Subject: **PETITION FOR INSIGNIFICANT PROJECT CHANGE FOR ADDITIONAL SAFETY PLATFORMS AT MAGNOLIA POWER PROJECT (01-AFC-6)**

PETITION FOR INSIGNIFICANT PROJECT CHANGE
FOR
ADDITIONAL SAFETY PLATFORMS
AT
MAGNOLIA POWER PROJECT

At Magnolia Power Project several areas have been identified where additional safety platforms are needed to improve operations and maintenance access to the process equipment. The areas are shown on the attached Site Plan (Drawing No. 010-G-002).

010-G-002

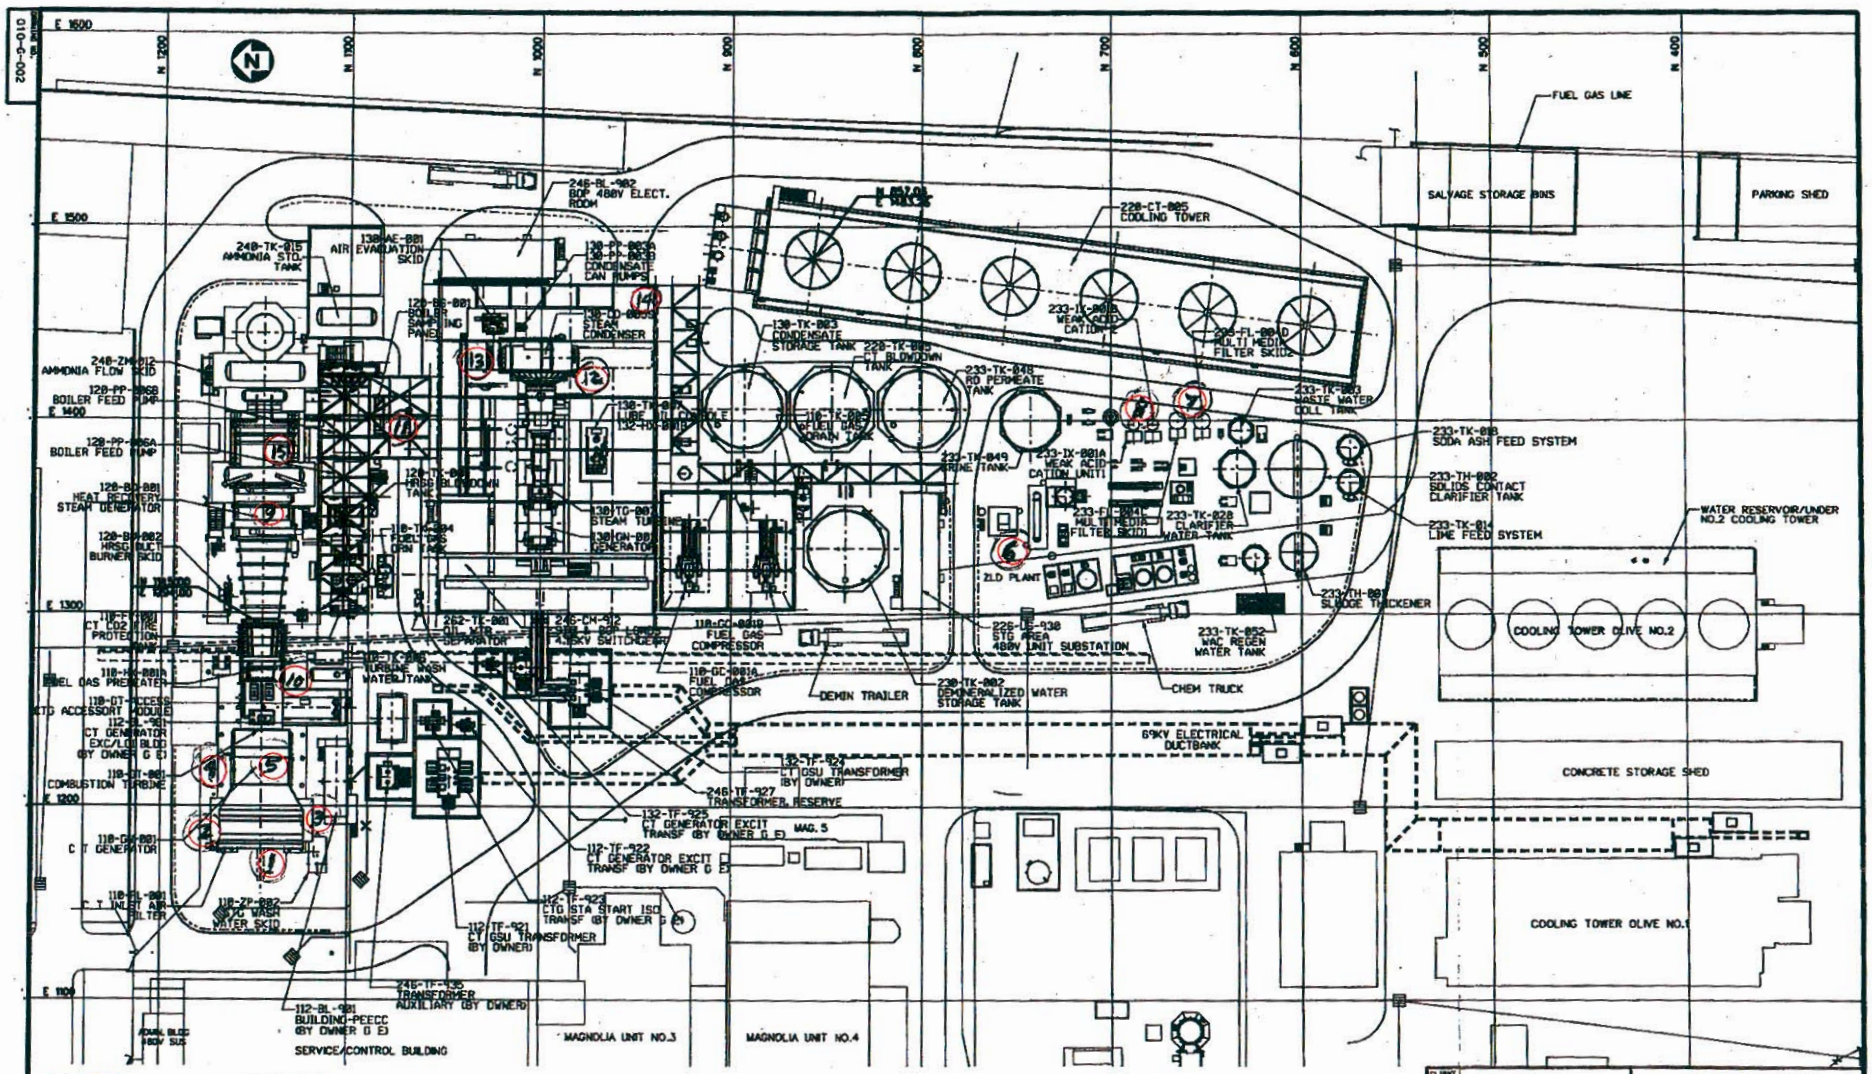
- Items 1 thru 5: There are five (5) platforms proposed to allow access to doors in the CT Generator Compartment, CT Load Compartment, and CT Terminal Enclosure – these are platforms to access the west end of the Generator Collector Compartment, the doors on both the north and south sides of the Load Compartment between the Generator and the Turbine Compartments, and the doors on the east end of the terminal enclosure compartment. These platforms will include stairways, ladders, and catwalks as needed to facilitate access. (Historically, GE provide these platforms with their Combustion Turbine-Generator equipment, however, GE recently discontinued the practice of supplying platforms with their equipment.)

- Item 6. A stairway is proposed to replace an existing ladder on the northeast end of the platform accessing the forced circulation heat exchanger and belt press in the ZLD Area. Operators tend to this equipment multiple times per shift, so a stairway is appropriate

- Items 7 & 8. There are four vessels in the ZLD area (two Multi-Media Filters and two Weak Acid Cation Units) that require working platforms atop the vessels to change-out the media or resins inside the vessel beds. Although clips are provided for the attachment of ladders and platforms on these vessels, none were provided by the original equipment manufacturer. The frequency of changing the resins and media in these vessels necessitates addition of the working platforms.

- Item 9. A short monorail with a two-wheel trolley is needed – atop the HRSG - above the HR Outlet Safety Valve (1HR-PSV213 aka 120PV002A) to allow the mechanics to remove this safety valve periodically for maintenance.

- Item 10. A ladder is needed to access the top of the Turbine Compartment for maintenance of the fan modules up there.

- Item 11. Ladders and platforms are needed for access to three bypass valves located in the piping between the HRSG pipe rack and the STG Building. It is necessary for mechanics and instrumentation technicians to perform maintenance on these routinely.

- Item 12. Platforms with ladders are needed to access manways on the south side of the Condenser. This multilevel platform is needed to facilitate inspection, brushing, and air lancing of the condenser tubes, as needed to maintain cleanliness on the circulating water side of the tubing inside the Condenser. This platform will be erected inside of the STG Building.

- Item 13. A small platform with a ladder is needed to access the blower motor control boxes above the Gland Steam Condenser. The control panel needs to be routinely accessed by operations personnel. This platform will be erected inside of the STG Building.

- Item 14. A ramp is needed for access to the bridge crane platform inside the STG Building for necessary inspections and maintenance of the crane rigging. This platform will be erected inside of the STG Building.

- Item 15. A platform with ladder is needed for access to inspect the silencers atop the HRSG. This platform will be installed above the silencer support structure, and will be equipped with a ladder lock to prevent uncontrolled access. This one is the only proposed platform to be installed where it could be visible from outside the plant area. To mitigate visual impact this platform will be galvanized like the silencers, with supporting members painted the same color as the existing silencer support structure.

SILENCER ACCESS PLATFORM
PLANS AND SECTIONS

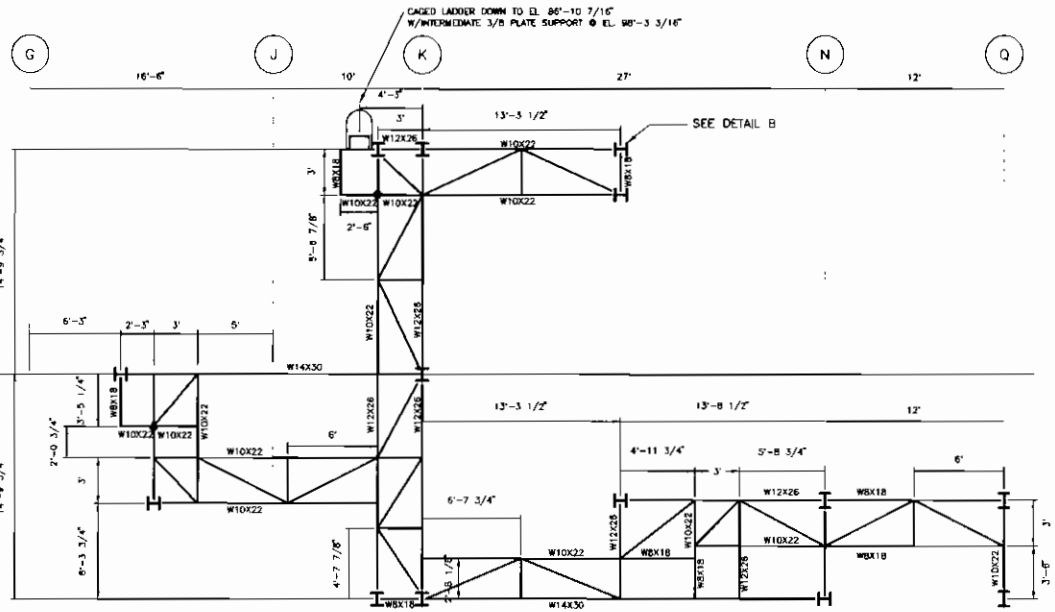
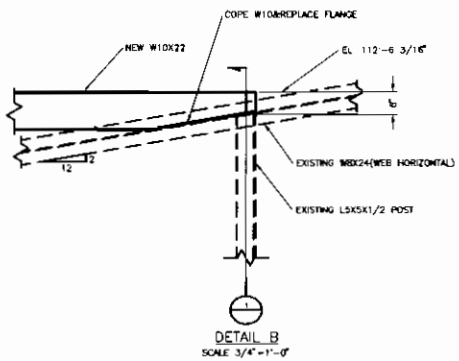
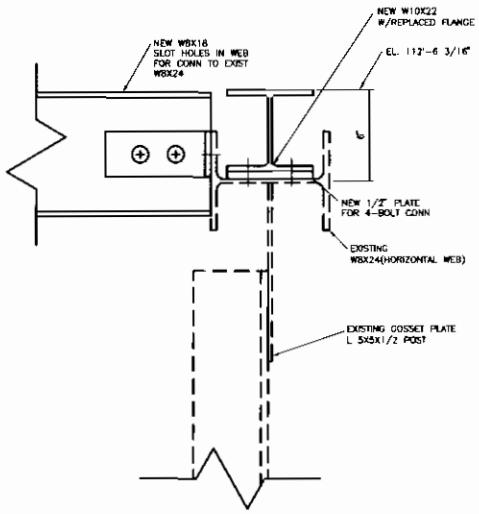
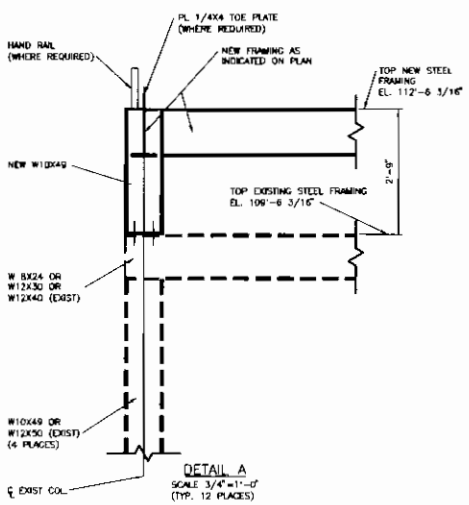
The additional platforms proposed will have no significant adverse impacts on the environment. The only possible impact identified is the potential visual impact of the proposed Silencer Inspection Platform atop the HRSG (Item 15 above). To mitigate any significant adverse visual impact, the platform is set-back from the periphery of the structure and is located mostly behind the existing silencers. To blend-in, the platform will be galvanized (like the silencers), and the supporting structure will be painted the same color as the existing silencer supporting structure. In Appendix A four perspective views are modeled to illustrate the appearance of the top of the HRSG (before and after the silencer inspection platform is added).

1. EXISTING FRAMING TO BE FIELD DRILLED FOR 4-BOLT CONNECTION AT POSTS.
2. ALL STEEL FRAMING ON THIS SHEET SHALL BE SHOP PAINTED IN ACCORDANCE WITH COATINGS SYSTEM DATA SHEET AS OWNER WILL SELECT COLOR
3. HANDRAIL, TOE PLATE, AND GRATING SHALL BE GALVANIZED.
4. ALL DIAGONAL BRACING SHALL BE L3X3X3/16.
